## PRODUCT/PROCESS CHANGE NOTICE (PCN)

<b>PCN #:</b> TB0605-05 <b>Product Affected:</b> CVBGA 52L & 56L Products <span style="margin-left: 100px;"><b>shipped in tray</b></span>	<b>DATE:</b> 7/01/06	<b>MEANS OF DISTINGUISHING CHANGED DEVICES:</b> <input type="checkbox"/> Product Mark <input type="checkbox"/> Back Mark <input type="checkbox"/> Date Code <input checked="" type="checkbox"/> Other
<b>Date Effective:</b> 7/31/2006		New tray quantity - 364 units/tray Shipment starting from 31-Jul-2006

### ATTACHMENT I - PCN #: TB0605-05

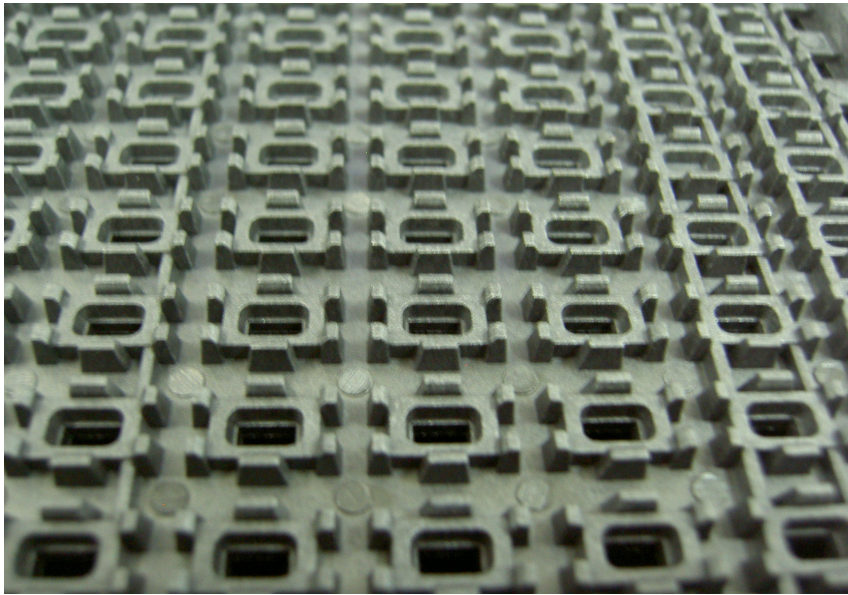
**Detail of Change:** This notification is to advise our customer that IDT has qualified new shipping trays for CVBGA 52L and 56L products. The new trays provide better protection during product shipment.

Please note that there will be a change in number of units per tray from 325 to 364 units/tray. There is no change in the tray dimensions.

Description	Existing Shipping Tray	New Shipping Tray
Part Number	12C-4570-E19	1QG-4570-F19
Tray Matrix	13x25	14x26
Qty per Tray	325 units	364 units
Pocket Size (WxL)	4.67x7.17 +/- 0.08mm	4.64x7.14 +/- 0.08mm
